# **PJM RTEP–2014 Window #2 Addendum 2 Proposal Window Problem Statement & Requirements Document**

**Scope: 2019 N-1-1 Voltage Drop Reliability Criteria**

Original Document: February 24, 2015

**2014 RTEP Window 2 Addendum 2 Proposal Window**

**Impacted Proposals – 12/18/2014 TEAC Webcast Slide 45**

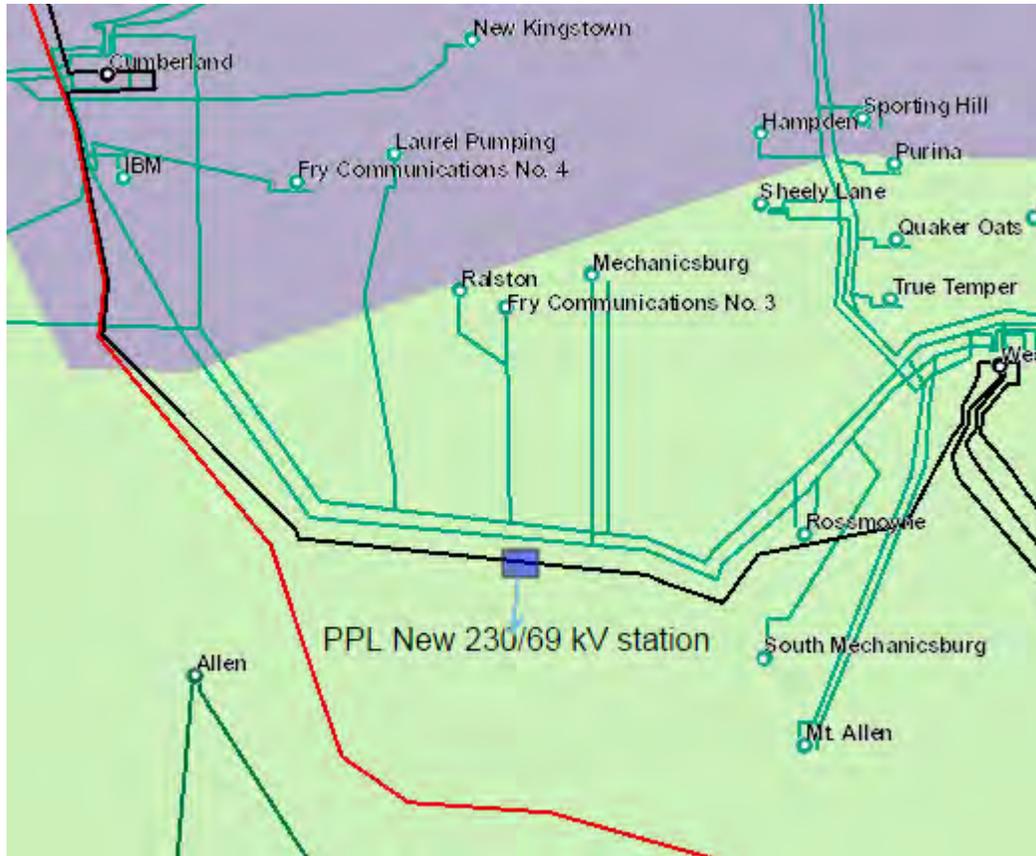
The purpose of this addendum is due an error in modeling of the S0859 upgrade submitted by TO. The 69 kV model of the S0859 was modeled incorrectly.

This proposal window is a result of a transmission topology assumption that has changed in the PPL transmission zone since the original RTEP Proposal Window #2 was closed. This addendum window is intended to give stakeholders extra time to develop modified proposals in addition to the time that was allocated for the original window. This topology change has the potential to impact the scope, feasibility and effectiveness of the proposals that were submitted as part of 2014 Proposal Window #2. The topology change only impacts flowgates in the vicinity of Allen 115 kV and Gardner 115 kV. The updated topology was not known and not modeled in the 2014 RTEP Proposal Window #2 but is modeled in the corresponding files to this addendum window.

The new topology will include the S0859 upgrade proposed by PPL. PPL is building a new 230/69 kV substation by tapping the Cumberland to West Shore 230 kV circuit. The new station will be tapped on the 230 kV circuit and will be located at approximately 63% of the total distance from Cumberland substation. In addition, a high level depiction of the location of the topology change is below. The image in the high level depiction is produce by PJM based on locational data provided by PPL. The PPL proposed supplemental upgrade is (S0859) to build 230/69 kV station by tapping the Cumberland – West shore 230 kV circuit. The new substation will be located about three miles from Allen station. The PPL upgrade doesn't impact the previous or current analysis result; however it has an impact on the proposed solution.

- N-1-1 Voltage Violation:
- Voltage drop violation in the Allen and Gardner vicinity for the N-1-1 contingency loss of the Hunterstown – Texas Eastern – Gardner and Middletown Jct. – Collins – Newberry – Round Top 115 kV circuits.
- Alternatives Considered:
  - 2014\_2-7B (\$22 M)
  - 2014\_2-4E (\$19.33 M)
  - 2014\_2-3A (\$16.13 M)
  - 2014\_2-4D (\$1.96 M)
- Still evaluating the upgrades due to assumption changes in the area
